**Blanding Armory-Roofing Improvements
Blanding, Utah**

Project Number: 04145470

Addendum Number 1

10 January, 2005

ROOF ACCESS LADDER SECTION		
ADDENDUM #1		
HAROLD P. WOODRUFF ARCHITECT/PLANNER 223 East 800 South Salt Lake City, Utah 84111 801-355-8684	State of Utah-DFCM Utah National Guard Salt Lake City, Utah Blanding Army Roofing Improvements Blanding, Utah	DATE: 01/10/2005
		SHEET NUMBER: AD-1

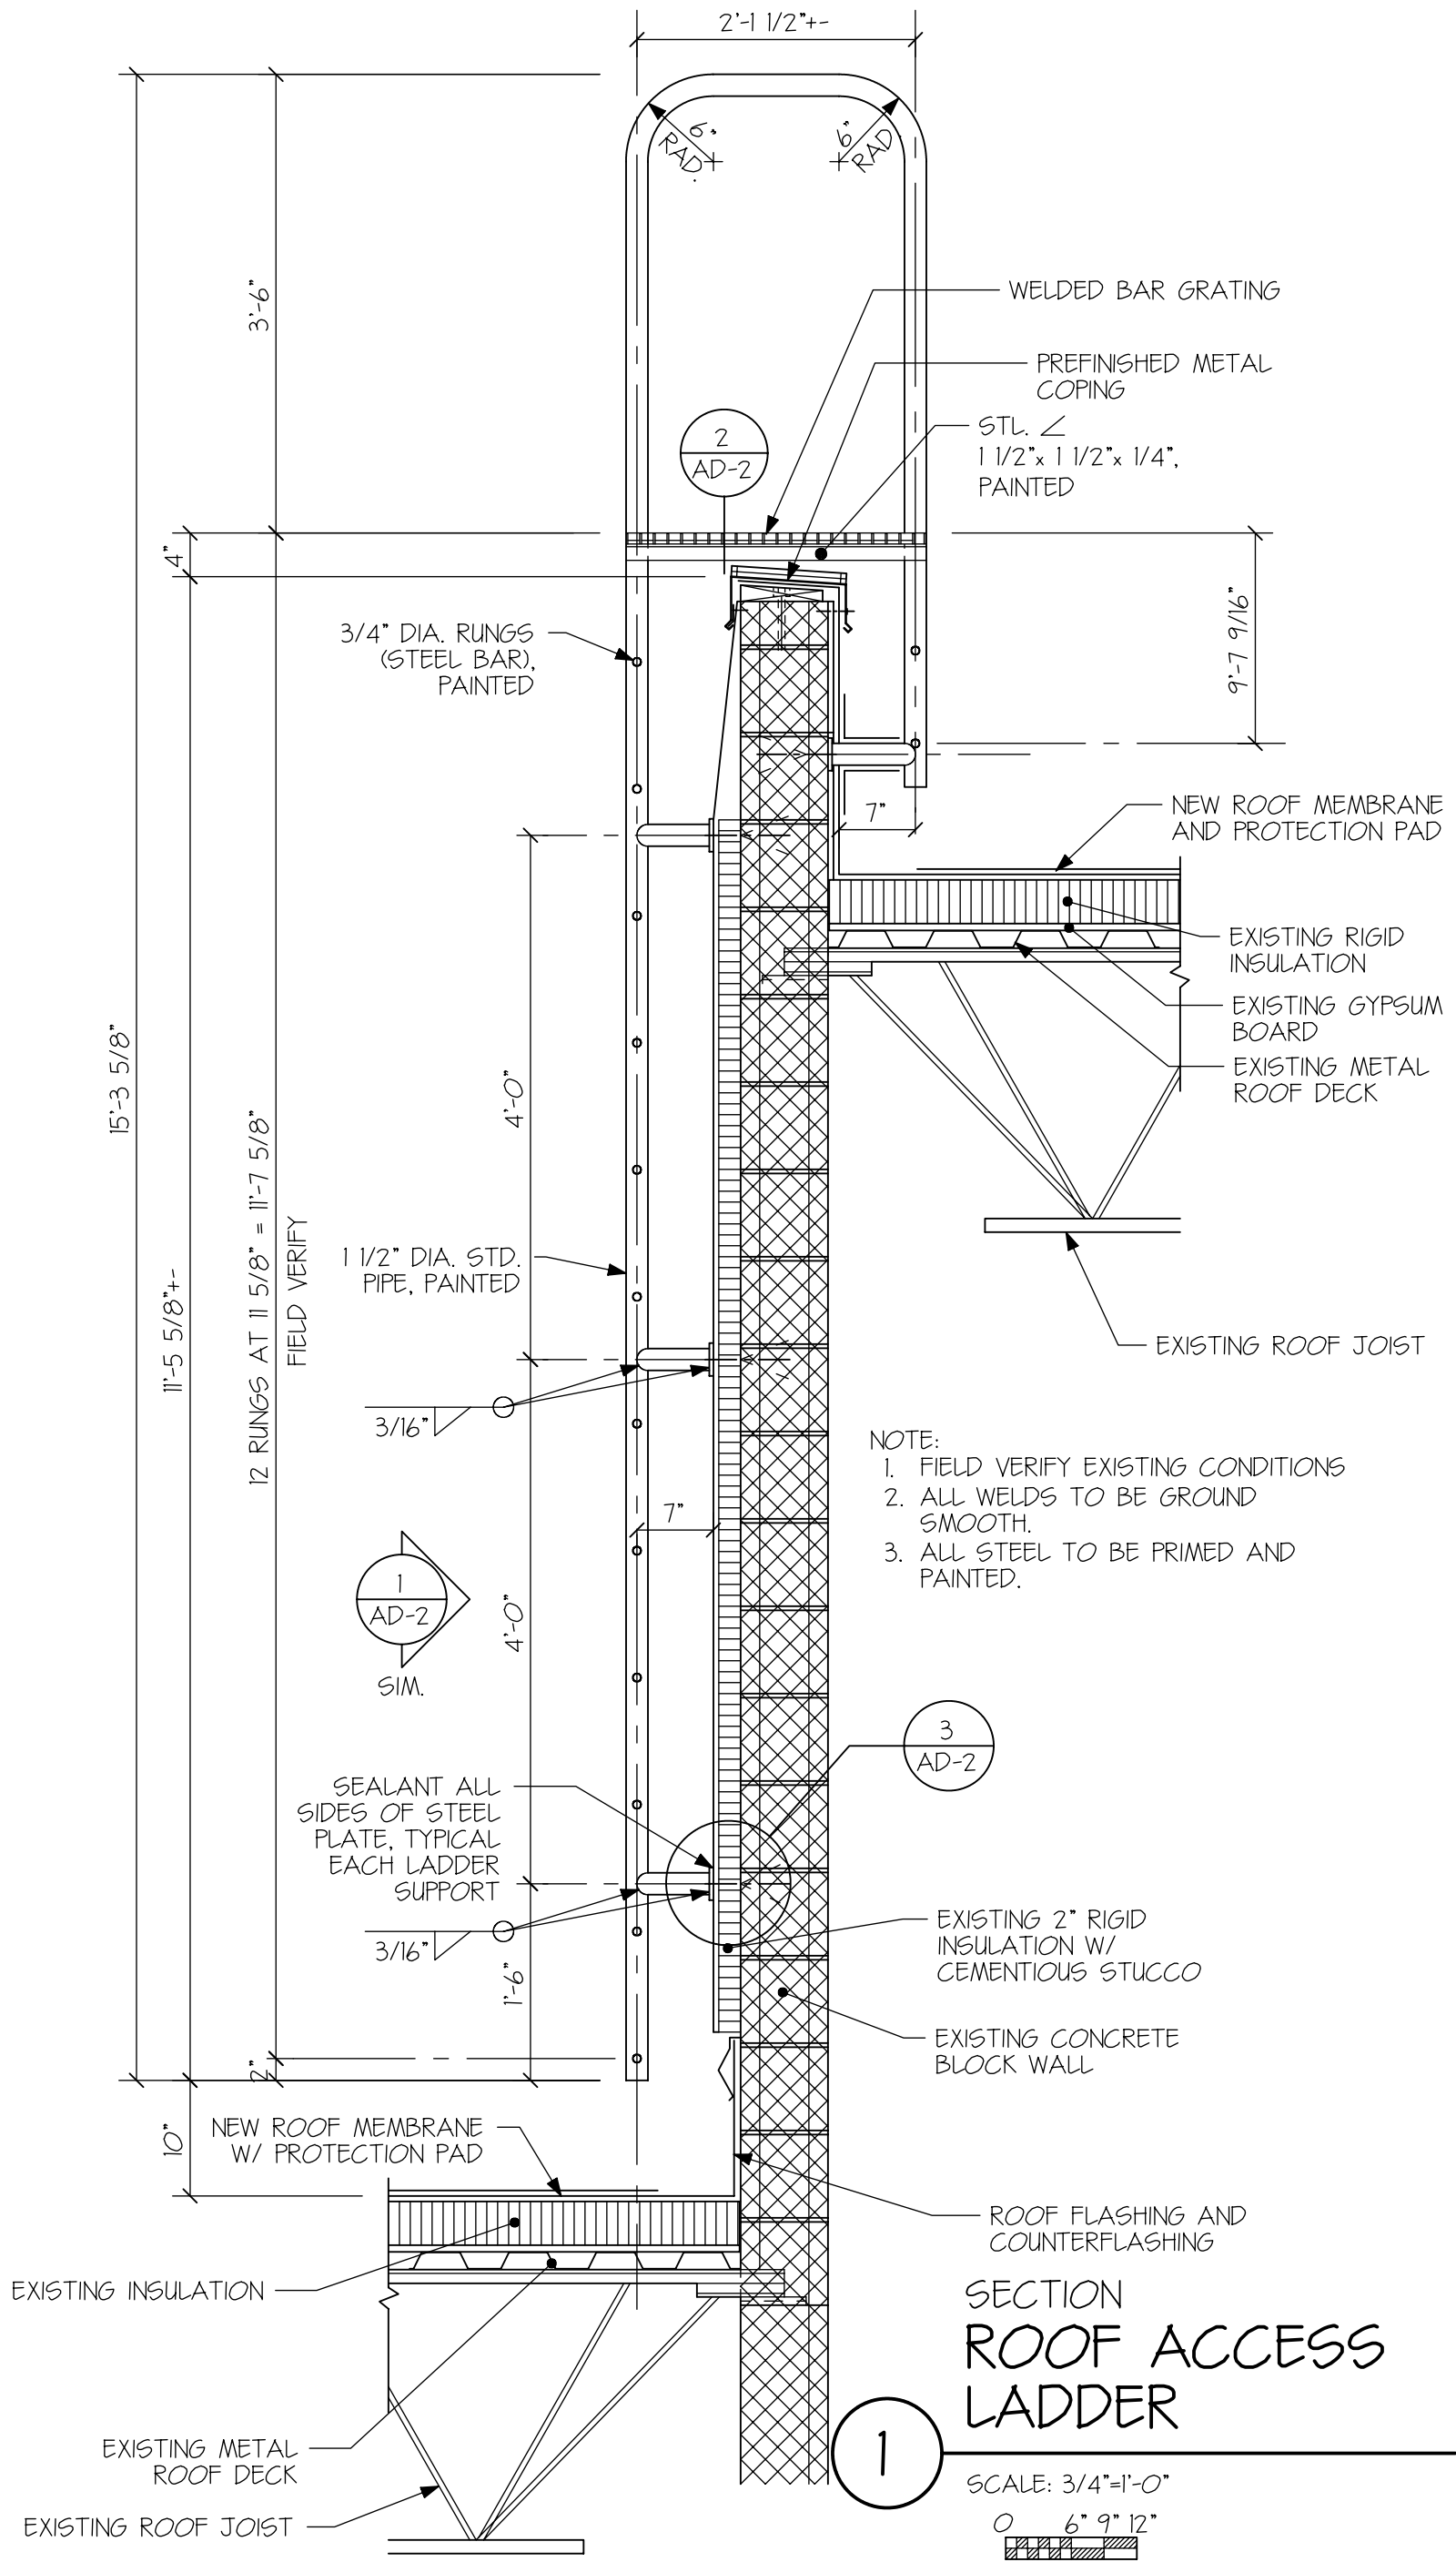
5. Due to a training schedule change the first area of the roof to be reroofed will be the lower, northwest roof corner of the building roof.
6. A roof access ladder will be installed on the west side of the building, from the lower roof to the upper roof. See attached drawings AD-1 and AD-2.
